UNITED STATES ENVIRONMENTAL PROTECTION AGENCY REGION 4

MEMORANDUM

SUBJECT: 2009 GW Monitoring Report for the Grenada Manufacturing Site
FROM: David N. Jenkins, Environmental Scientist
Technical Support Section, Superfund Support Branch
THROUGH: Glenn Adams, Section Chief, Technical Support Section, Superfund Support Branch
TO: Meredith Anderson, RCRA Project Manager
Meredith,

Brown and Caldwell, 2010, Annual Monitoring Report Calendar Year 2009, Grenada Manufacturing, LLC, Grenada Mississippi, Brown and Caldwell, 4000 Lakehurst Court, Dublin, OH 43019.

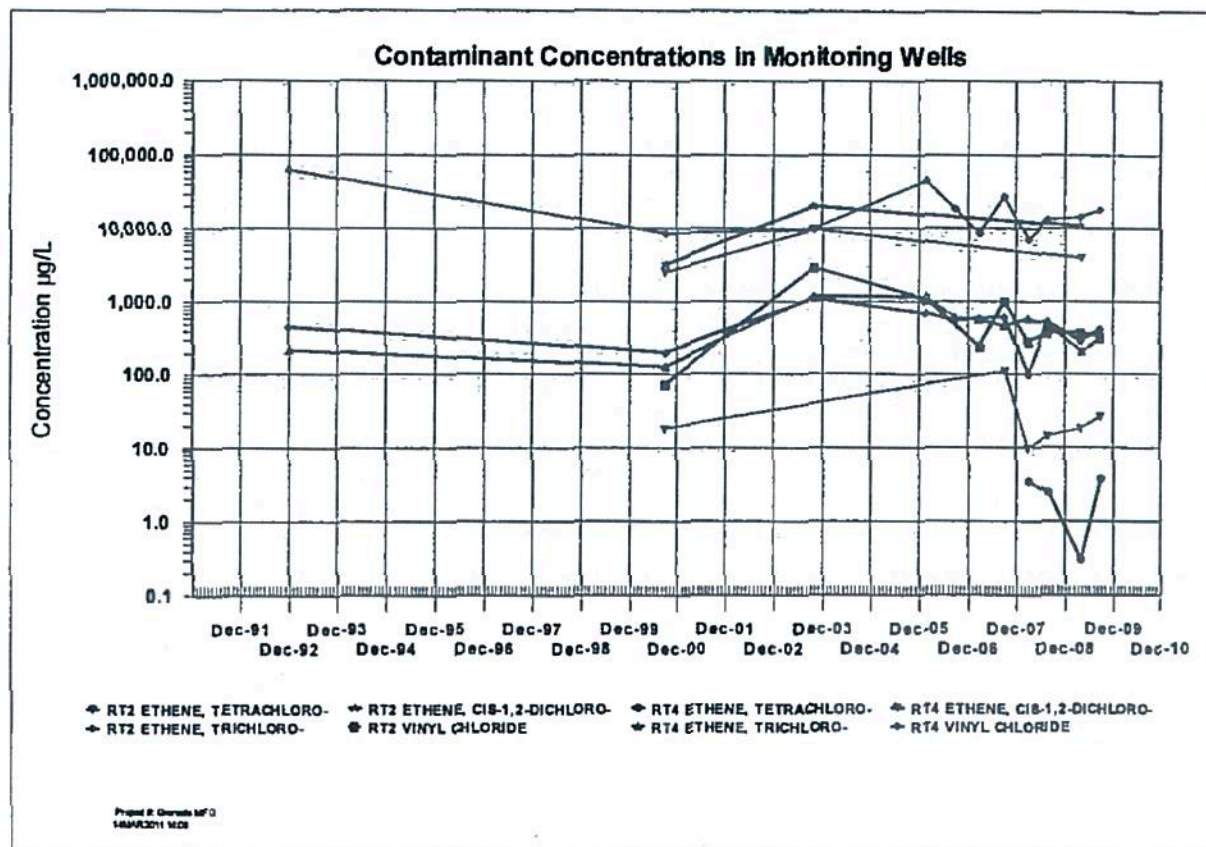
The following graph shows chlorinated VOC concentrations in wells RT-2 and RT-4. This graph was made from the data in Table 5, but the report does not contain any trend graphs. Please note the graph must be viewed in color to be useful because 4 contaminants from 2 different wells are plotted. The graph is busy, but purpose of this particular graph is to illustrate overall trends only. Two important observations to be made from this graph are:

- 1.) the concentrations in many wells exceed the relevant MCLs, and
- 2.) concentrations are not decreasing.

The last point can be verified with a ruler to draw a horizontal line across the graph. The oldest analysis result for many of these contaminants is less than the youngest result, showing that contaminant concentrations are increasing over the last 10-18 years despite any degradation by natural attenuation. The graph does not show a meaningful decrease in contaminant concentrations versus time.

The vinyl chloride concentration in RT-2 is a good example of increasing contaminant concentrations. In this case, the increase could be the result of degradation of other cVOCs, but the most recent vinyl chloride concentration is more than oldest VC concentration in this well. The most recent VC concentration in RT-2 is 150 times greater than the MCL. cis-DCE concentrations have increased in both wells and have exceeded the MCL since they were sampled first in 2000. The TCE concentration in RT-2 has increased since 2000 and, as shown on the graph, this increase probably is not due to degradation of PCE. Even the concentrations which are decreasing are decreasing at rate too slow to result in cleanup in a reasonable time. An average trend line through these data would be nearly flat and relatively little degradation is apparent over a time period probably equal to a few TCE half-lives.

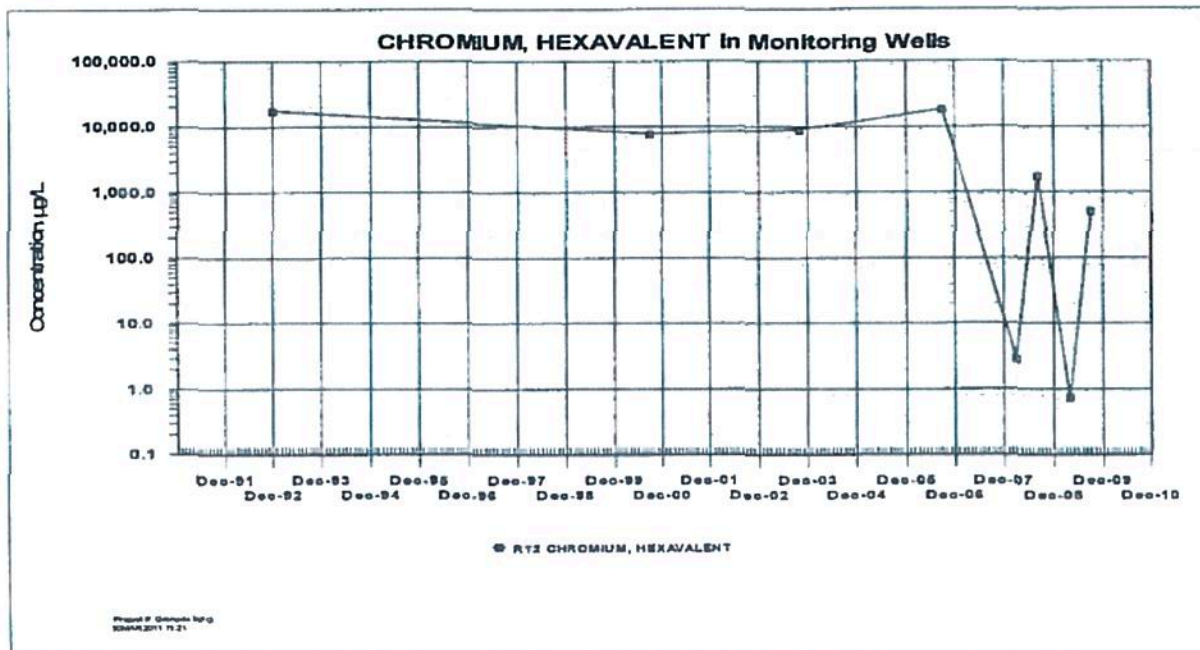
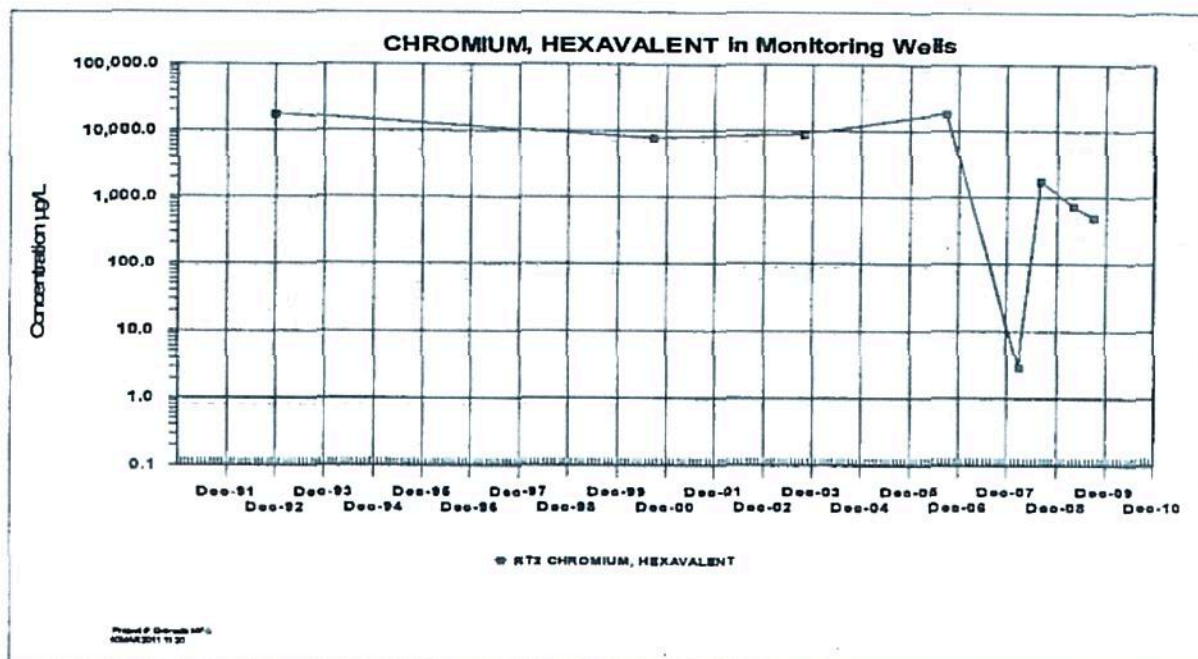
The trend graphs below show the difference between these two results.

You can see that the second downward pointing spike on the first graph disappears on the second graph when the value reported from Appendix B is plotted instead of the value in Table 7. I do not have the laboratory results for 2008 and cannot check the other downward spike shown on the graph. The 2008 data does not fit the hex-chrome data trend for this well.

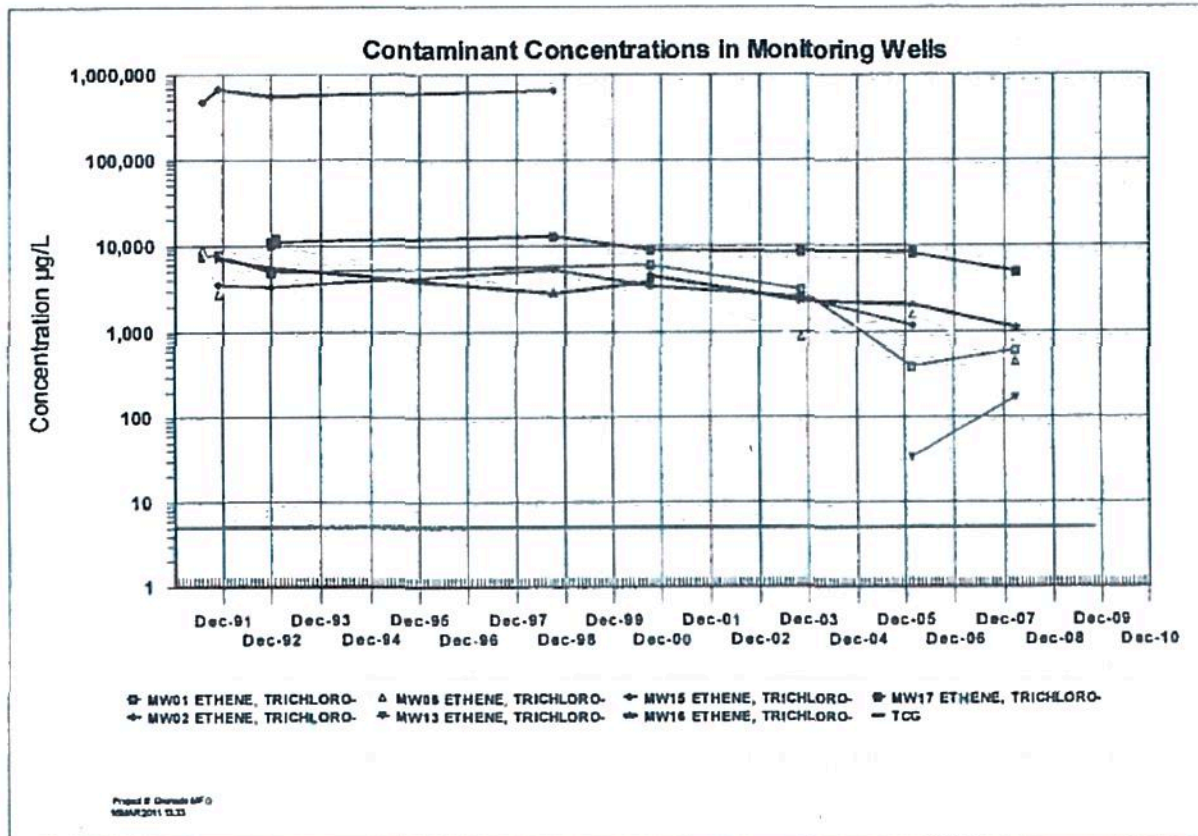
TCE concentrations in wells MW1, 2, 6, 13, 15, 16 and 17 from Table 5 are shown in the graph below:

All of these wells are hundreds of feet up gradient from the PRB wall (Figure 5). No figure in the report shows a TCE plume, but based on the TCE concentration in MW02 and the relatively stable TCE concentrations in MW17 over 15 years, the axis of this particular TCE plume is suspected to be in the upper zone near MW02. You can see that TCE concentrations in MW02 were very high when this well was sampled last in 1998. Well MW17 is located near this well, but MW02 is in the Upper zone while MW17 is in the Lower zone. TCE concentrations have decreased very little in MW17 since early 1993. Figure 5 shows there are no monitoring wells down gradient from MW02 and MW17 for at least 400 feet. The plume is migrating toward the PRB wall. The most contaminated portion of the facility has not been sampled since 1998.

The increasing TCE concentration in well MW13 is one piece of evidence that the margins of the plume are expanding northward (see the location of MW13 on Figure 5) and that the plume may flow around the north end of the PRB wall. There are not enough monitoring wells in the down gradient portion of this plume, particularly around the ends of the PRB wall.

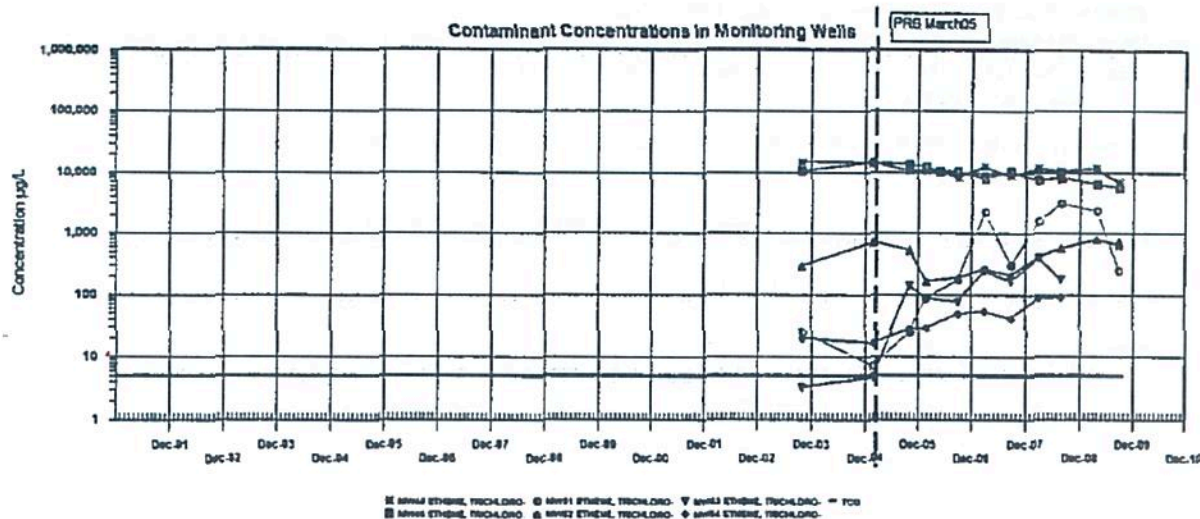
TCE concentrations in wells MW45, 46, 51, 52, 53 and 54 from Table 5 are shown in the graph below:

These wells are down gradient from the wells shown in the previous graph, but up gradient and relatively close to the PRB wall. Based on the relatively high and stable TCE concentrations, MW45 and 46 may be close to the axis of this TCE plume down gradient from MW02 and MW17. TCE concentrations in these wells are decreasing slightly, but are relatively stable, and are comparable with concentrations in up gradient well MW17 shown in the previous graph.

TCE concentrations in the deeper MW52 increased after 2006 and by 2009 became similar to concentrations observed when the wall was installed. TCE concentrations in the shallow wells MW51 and MW53 and deeper well MW54 all have increased since the PRB wall was installed. The increasing TCE concentration in these wells may be evidence that the margins of the TCE plume are expanding southward (see the well locations on Figure 5) and that the plume may flow around the south end of the PRB wall.

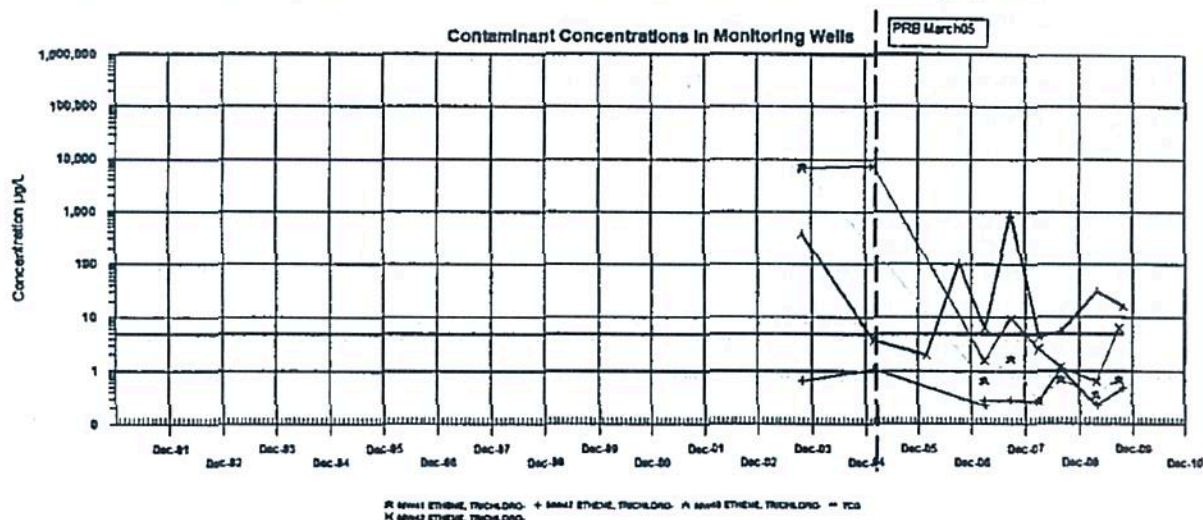
TCE concentrations in wells MW41, 42, 47 and 48 from Table 5 are shown in the graph below:

These wells are located down gradient from the PRB wall and away from the ends of the wall (see the well locations on Figure 5). TCE concentrations trends from these wells suggest the PRB wall lowered

TCE concentrations in these wells, though the concentration trend in deep well MW48 is erratic for reasons which are unclear at this time. The shallow well at this location, MW47, has never shown an exceedance for TCE. The erratic response in MW48 may be an indication that TCE contamination moves under the wall near MW48.

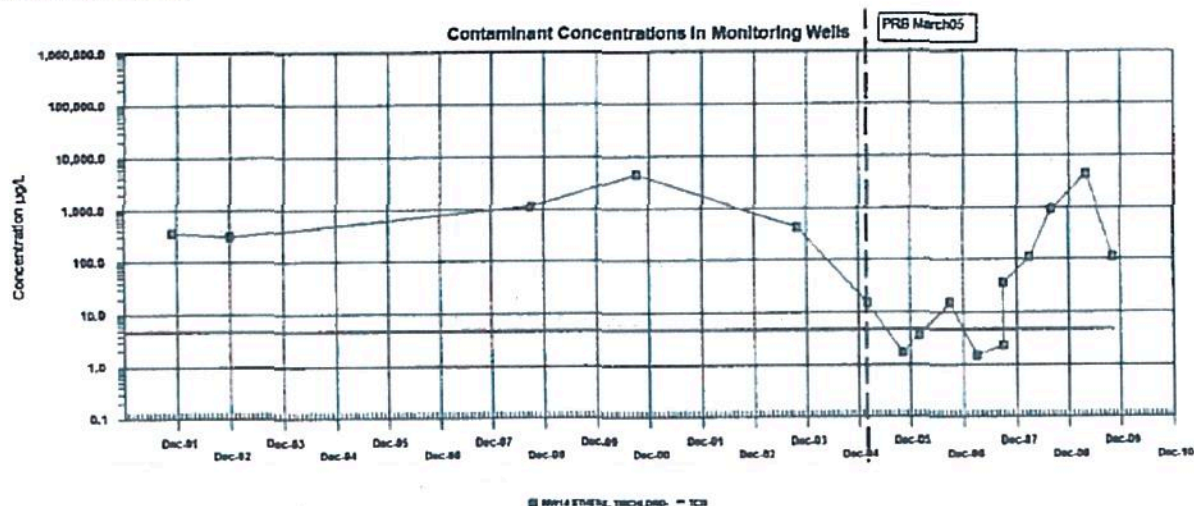
Unfortunately, on the down gradient side of the wall in MW14, the situation is even less clear as shown in the graph below.

The PRB wall may not have had any influence on TCE concentrations in well MW14. TCE concentrations were decreasing before the wall was installed. Three years after the wall was installed, TCE concentrations in this well increased to levels previously observed in 2000. The cause of these concentration variations is not addressed in the 2009 Monitoring Report. What is clear from Figure 5 is that MW14 is much closer to the surface water stream than it is to the wall. The TCE plume from MW14 discharges to the stream in this area. Without well screen depth information, without estimates of the vertical hydraulic gradient near MW14 and the stream and without information regarding the depth of the PRB wall, further interpretation of these data is not possible.

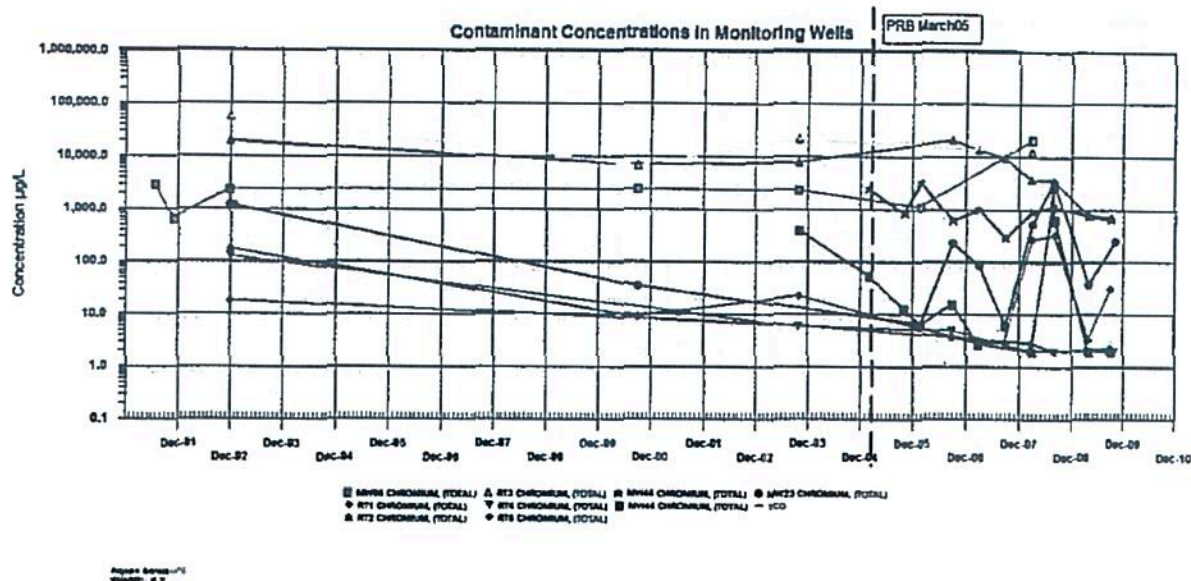
The MCL for total chromium is 100µg/L. Total chromium trends in selected wells are shown in the graph below and described in the following paragraphs.

Total chromium concentrations in MW06 have exceeded 1,000µg/L in 7 of 8 samples since 1991 and concentrations are increasing (Table 7 p.2/15).

Total chromium concentrations in the background well MW23 appear to be increasing, but the trend is very erratic for reasons not explained in the 2009 Monitoring Report. MW23 is the most up gradient well with MCL exceedances for total chromium, but with the erratic trend, the chromium source may be farther up gradient.

Total chromium concentrations in well RT3 have exceeded 10,000µg/L in all but one sample since the earliest reported samples in 1992.

Total chromium concentrations in well RT2 have exceeded 10,000µg/L in most samples before 2008, but recently have declined to 750µg/L.

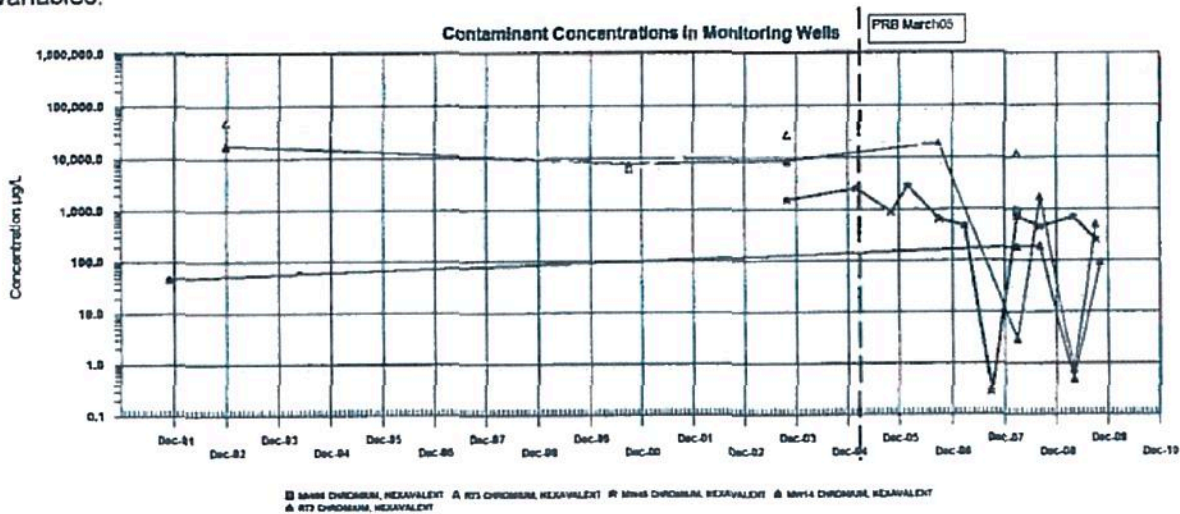
Total chromium concentrations in shallow well MW45 always exceed the MCL. Total chromium concentrations in well deeper well MW46 sometimes exceed the MCL, but the trend is erratic. The erratic trend in MW46 may be an indication that contamination sometimes passes under the wall at this location, but no information regarding the hydraulic gradients in this well pair is provided. Both of these wells screens are located relatively close to the PRB wall and are far down gradient from the RT wells.

Total chromium concentrations in well RT5 sometimes exceed the MCL, but the occasional exceedances are greatly different from the other results from this well. Turbidity in the sample might cause this response, but turbidity is not reported on Table 7.

Total chromium concentration in well RT1 has never exceeded the MCL and total chromium concentrations in well RT4 exceed the MCL only in January 1993. I first thought the old lagoon was the source of the chromium, but the typically low chromium levels in wells RT1, RT4 and RT5 suggest this is not true. MW23, RT2 and RT3 all are on the south side of the lagoon. The source of the total chromium plume is not clear from the data presented and the location of the plume is not shown on any map in this report. The extent of total chromium contamination in groundwater appears to extend from the PRB up gradient at least as far as MW23.
